**Special Assessment District #23, ARROWCREEK PARKWAY**  
**Hydraulic Report**  
**Whites Creek Branches 1, 2 and 3**  
**RETURN TO WASHOE COUNTY ENGINEERING**

June 9, 1997  
Revised August 22, 1997

This report was originally submitted to Washoe County Department of Public Works on June 11, 1997. As a result of comments provided by Washoe County, this revised report includes the following revisions:

**FIGURE 3**  
**FLOODPLAIN MAP**  
**WHITES CREEK BRANCH #1**

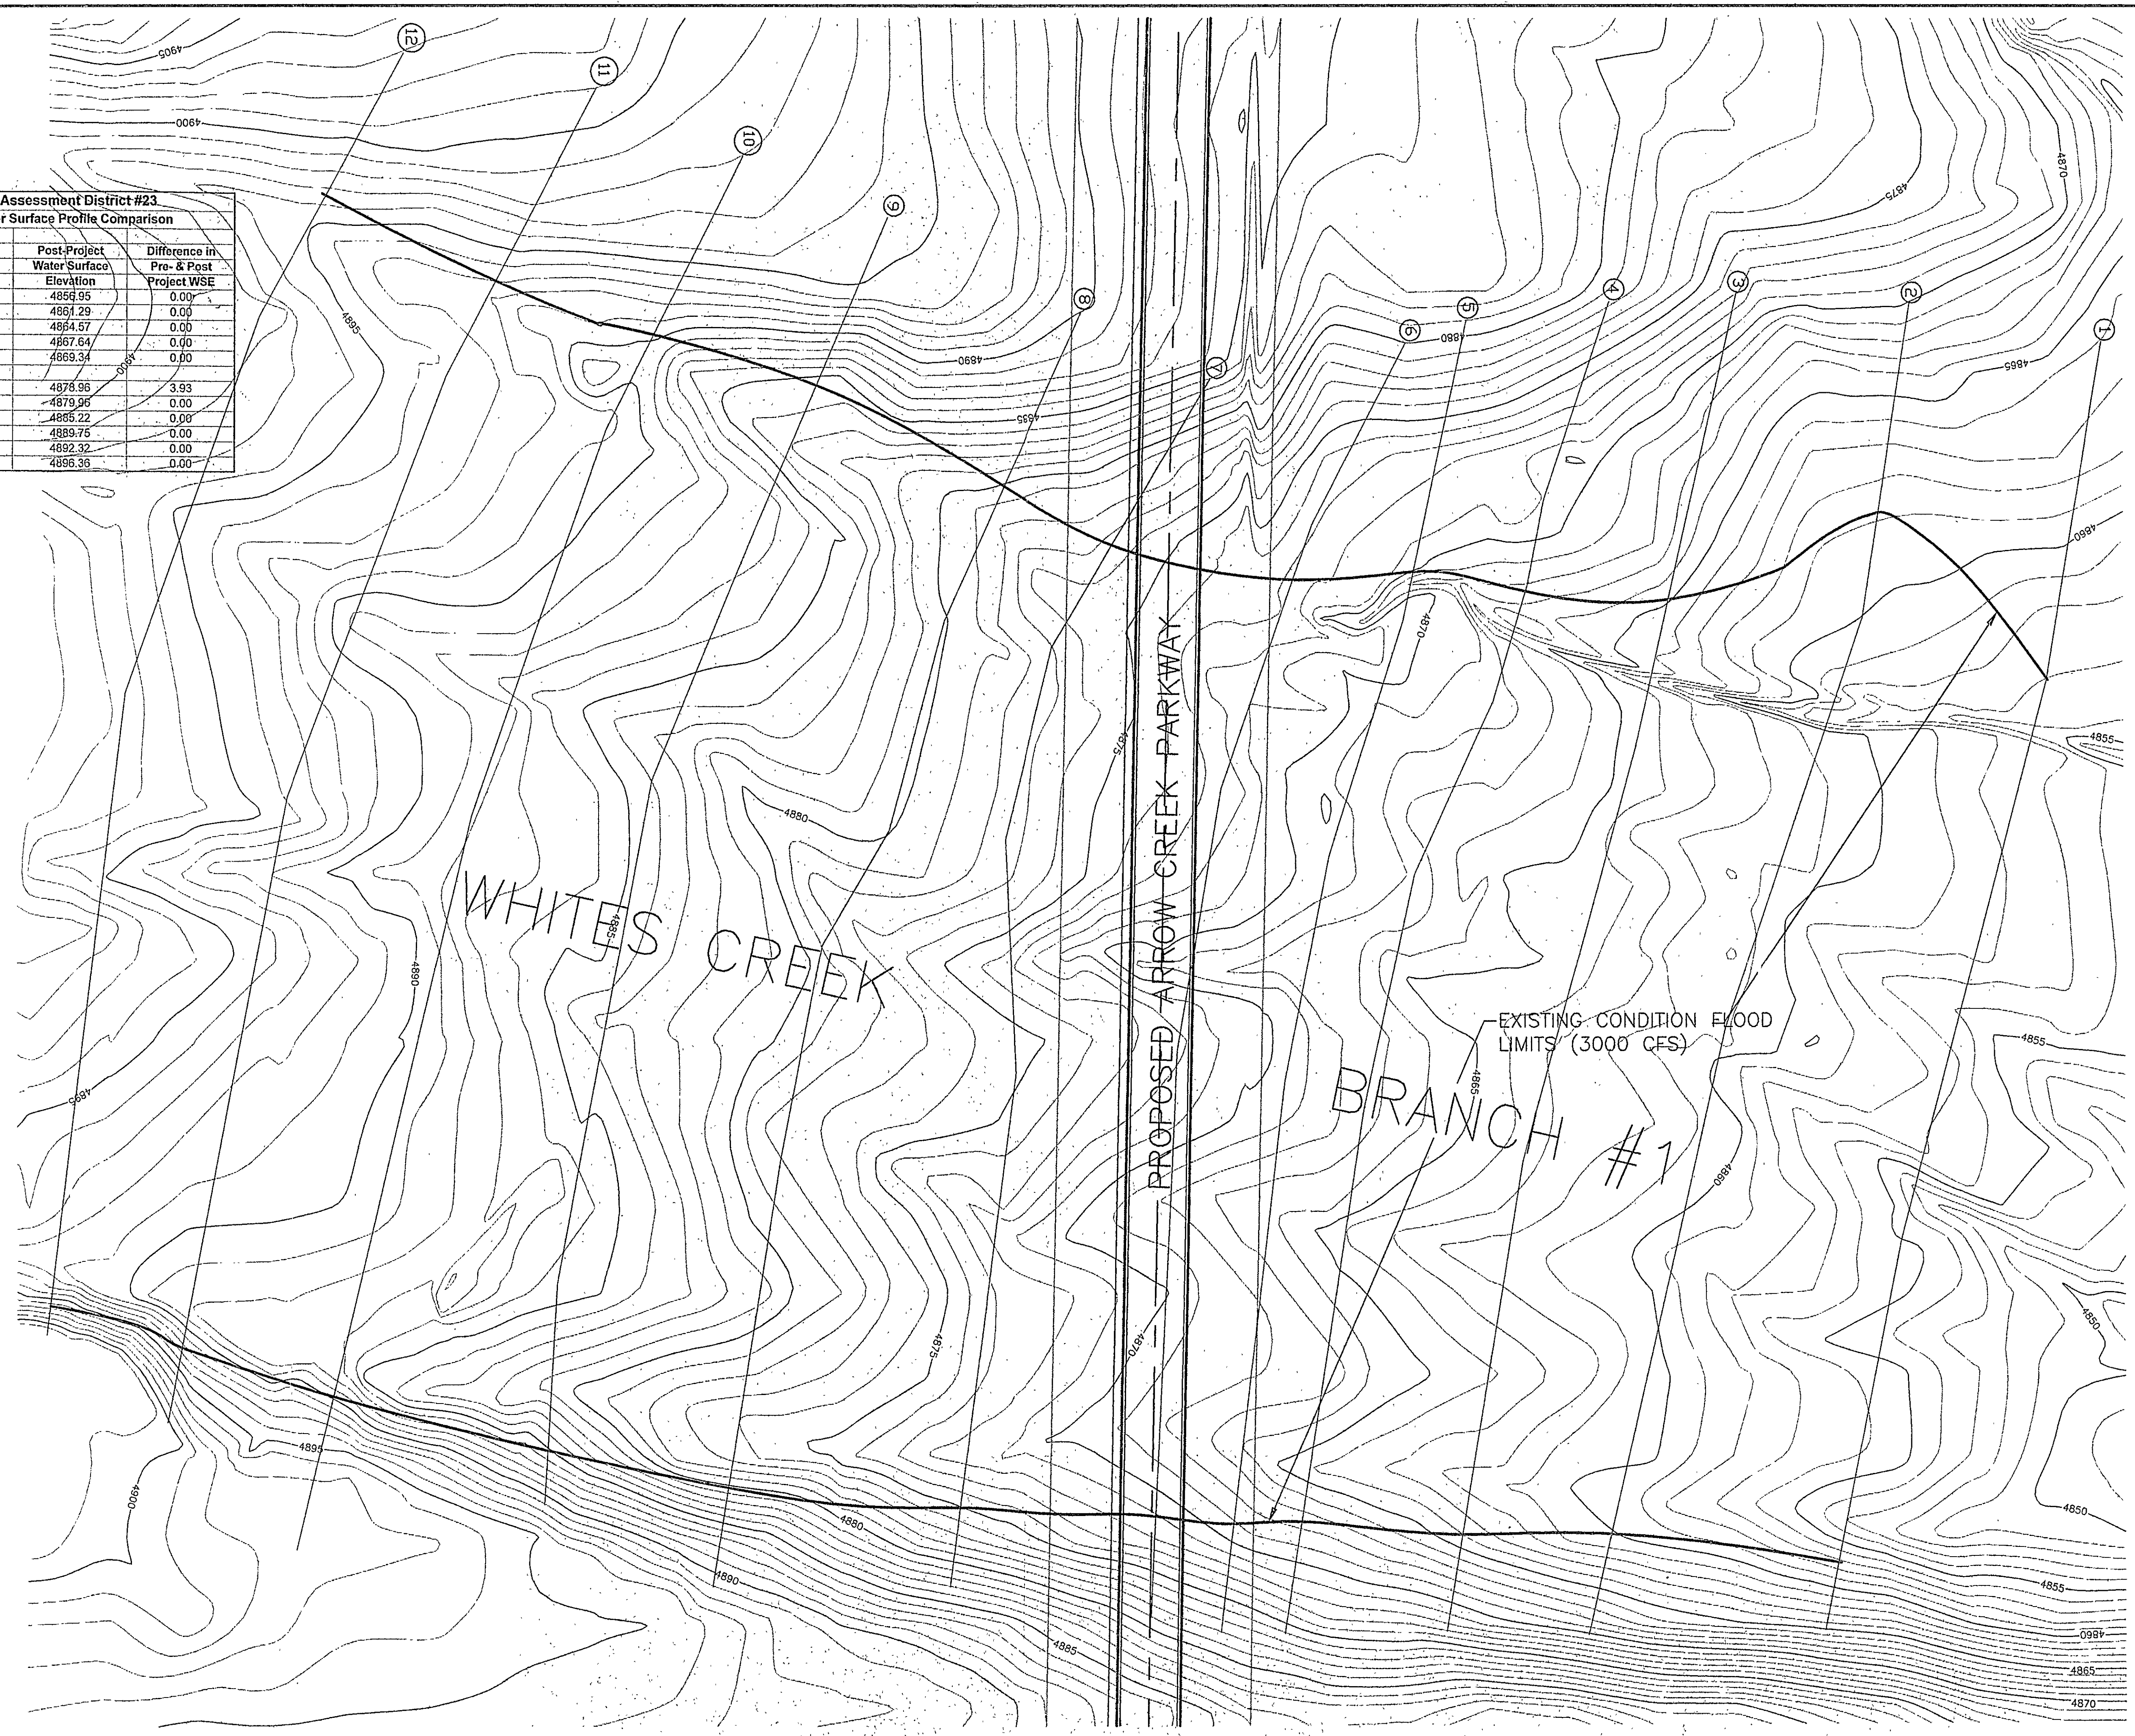
↳ TOO SMALL TO READ. WANT THIS INFO ON FIGURES 3+4

# Whites Creek Branch 1 - Post-Project Profile

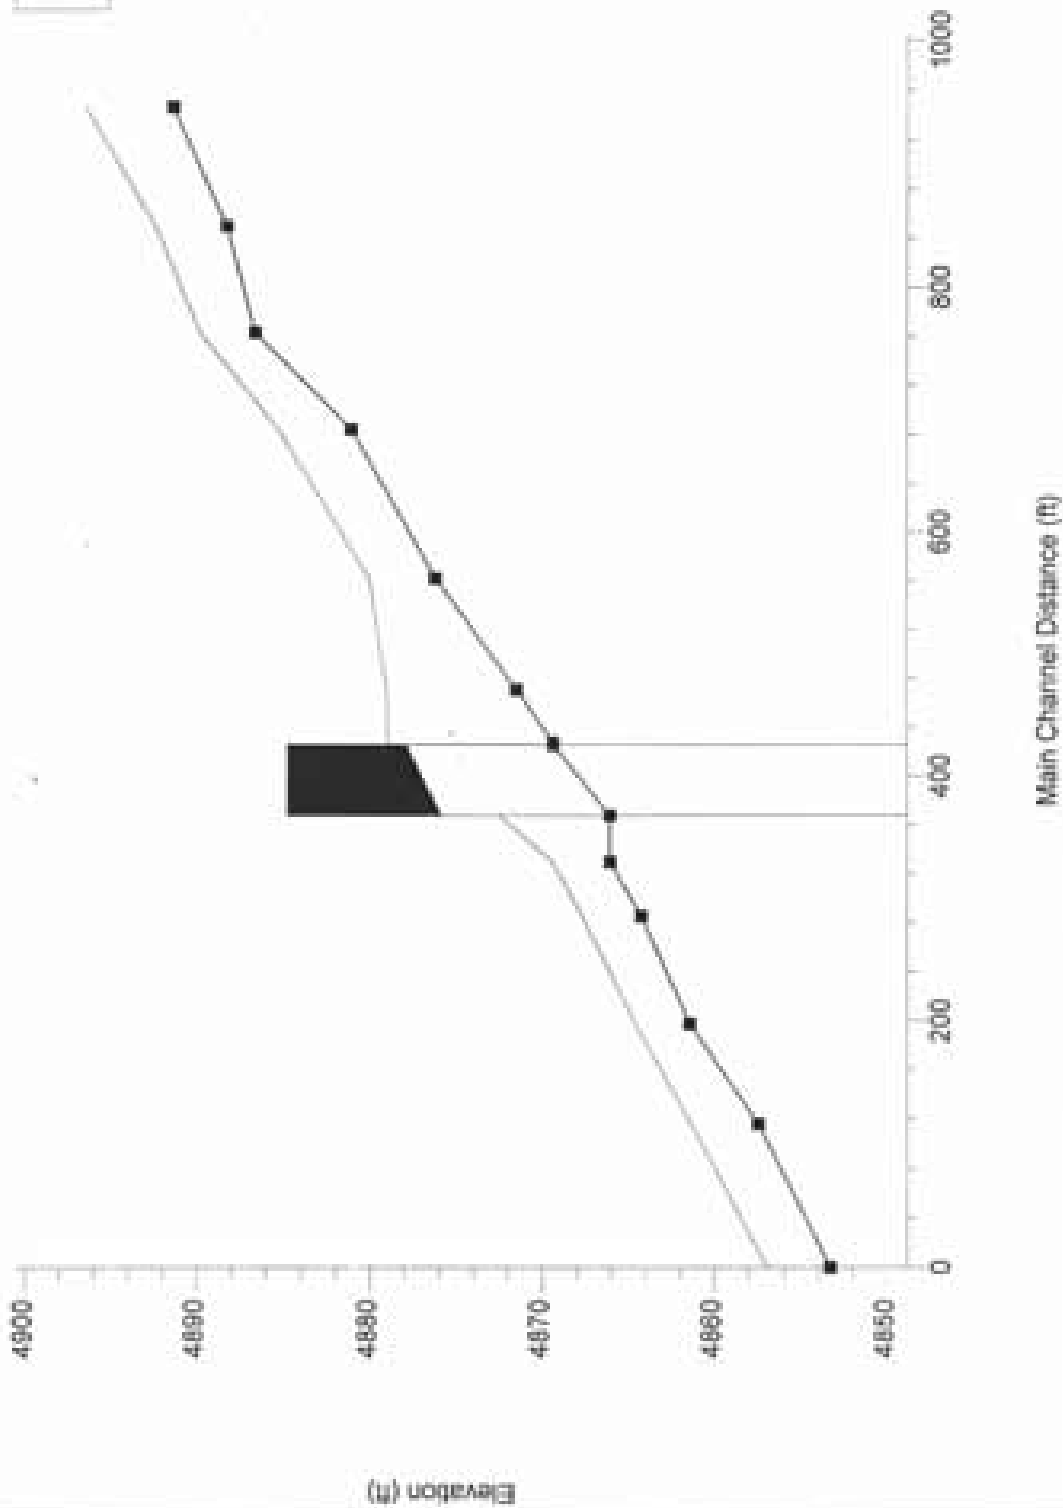
The results of the analysis are contained in Appendix C with a summary table showing the comparison between pre- and post-project conditions. The results show that there is an increase in the upstream water surface elevation of 2.5' immediately upstream of the roadway, but because of the steep topography, this impact diminishes within 200' upstream of the roadway and is less than 1' within 100' upstream of the roadway. *6.0" only 1.9' inc.?*
